Access Compliance Report

Public Rights-of-Way

(Pedestrian Signals)

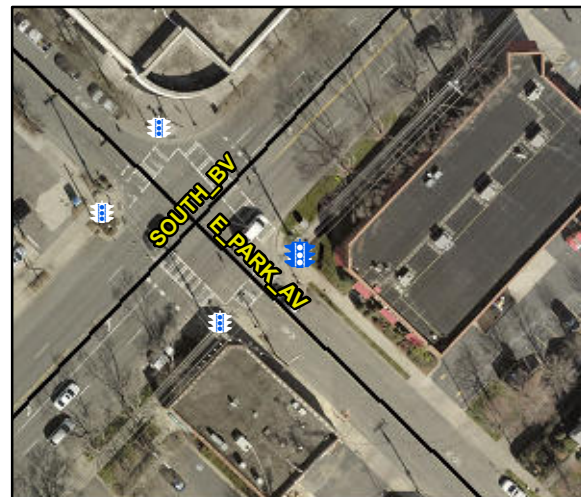
Intersection ID: N/A	Main Street:	Cross Street: N/A	Location: N/A
ADA ID: A91069B9C57C	Signal Type: One Push Button-Non APS	Overall Compliance: No	Severity Score: BTN 1: N/A BTN 2: N/A No BTN: N/A
Codes/Mitigation Info/Possible Solution		Field Measurements/Component Compliance

PROW/ADA: TMUTCD 4e.08, R406.2, R404.7.3

Possible Solutions: Replace Signal Push Button With APS Button on New Post. Remove & Relocate Sign.
